No. 205-06-121

MODEL AFFECTED: 205A & 205A-1

SUBJECT: VERTICAL FIN COVER HINGE PIN IMPROVED
INSTALLATION

Figure 1
New Hinge Pin Installation

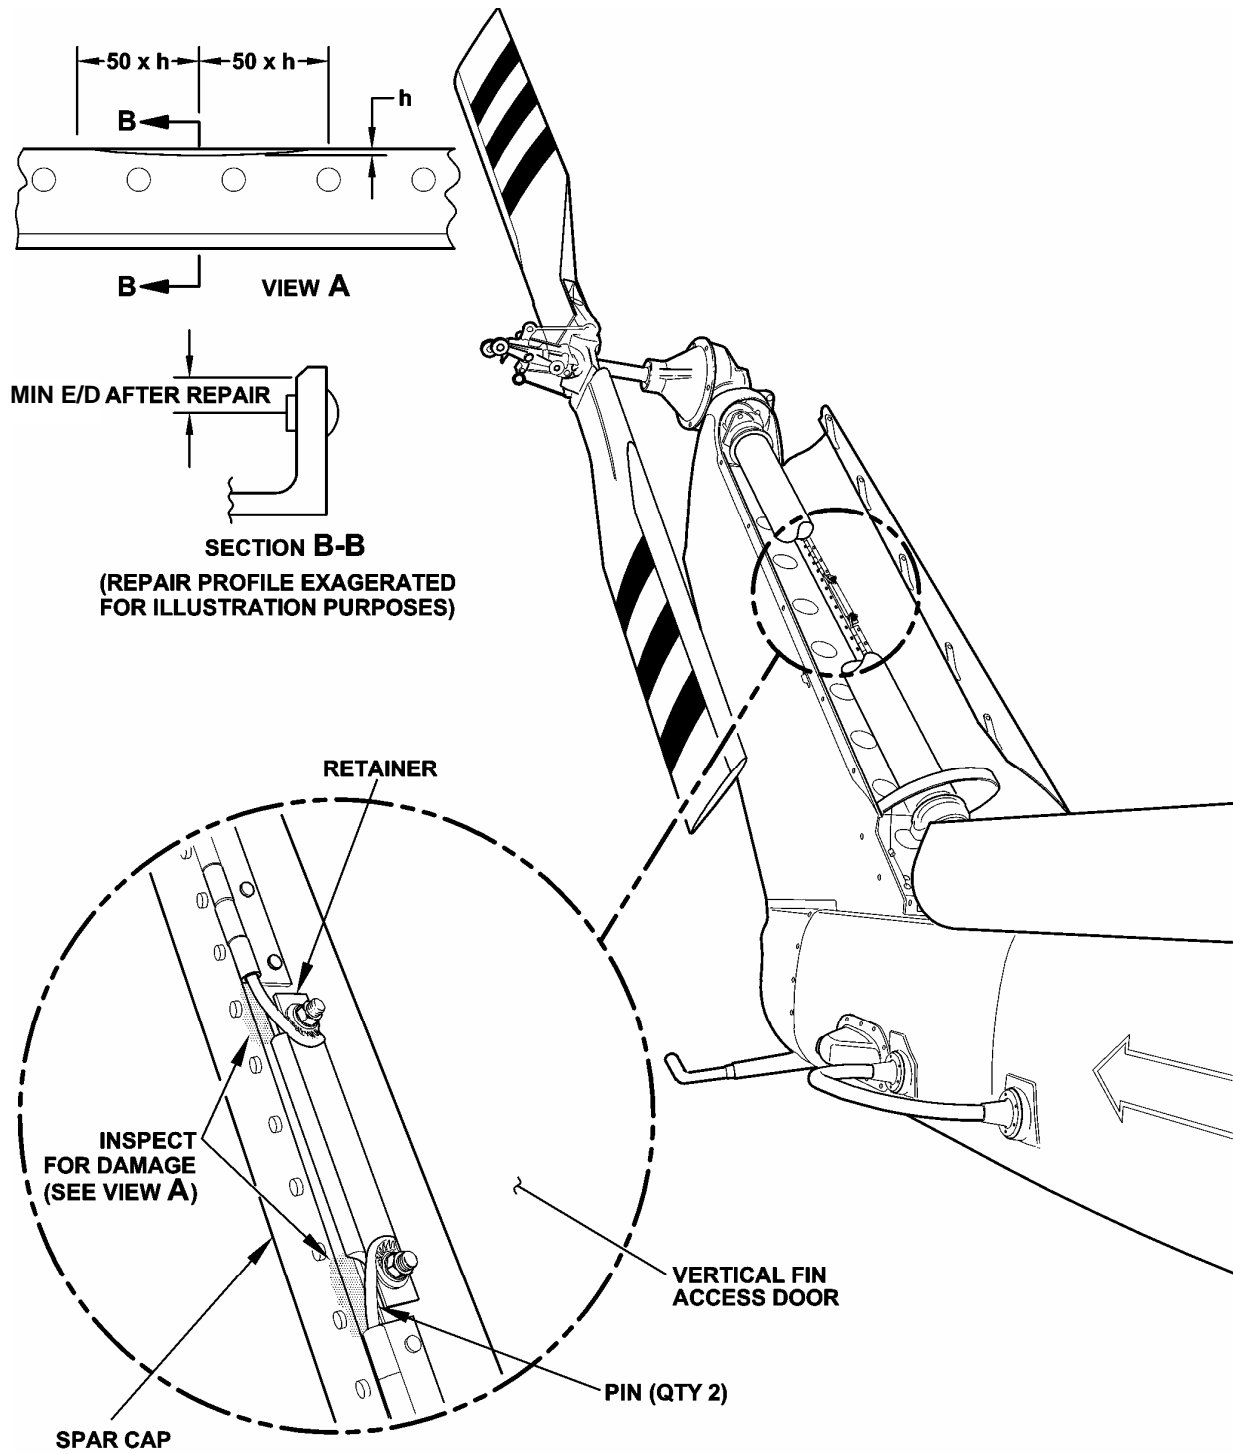
Bell Helicopter has designed a new installation for the vertical fin cover to prevent chaffing damage to the left hand spar cap caused by improperly bent hinge pins. This technical bulletin allows retrofit of the installation on 205A and 205A-1 aircraft.

5. Inspect spar cap as indicated in Figure 1, View A, for any chafing damage caused by improperly installed hinge pins.
 - a. Chafing damage of 0.040 inch-deep or less (up to the full width of the flange) may be blended to a length-to-depth ratio of 50:1 (in each direction from the deepest point) and refinished, provided the distance between the center of the nearest rivet and the repaired area is at least 1.5 time the rivet diameter (min E/D). Remove minimum amount of material and polish repair area using 400-grit sandpaper. Removal of the hinge from the fin may be required.

6. Reinstall door by inserting Pins P/N 209-031-816-119. Attach pins to door using existing screws, 209-031-816-123 Retainer and MS21042L3 Nuts, as shown on Figure 1. Close door.
7. Make an entry in helicopter historical records indicating compliance with this technical bulletin.
8. Make helicopter safe for flight.

- b. Perform a Fluorescent Penetrant Inspection per Standard Practices Manual, followed by application of chemical film to the repaired area per Structural Repair Manual Section 3-2-14. Refinish area in accordance with Standard Practices Manual.

- c. Report any damage in excess of 0.040 inch-deep to Product Support Engineering.
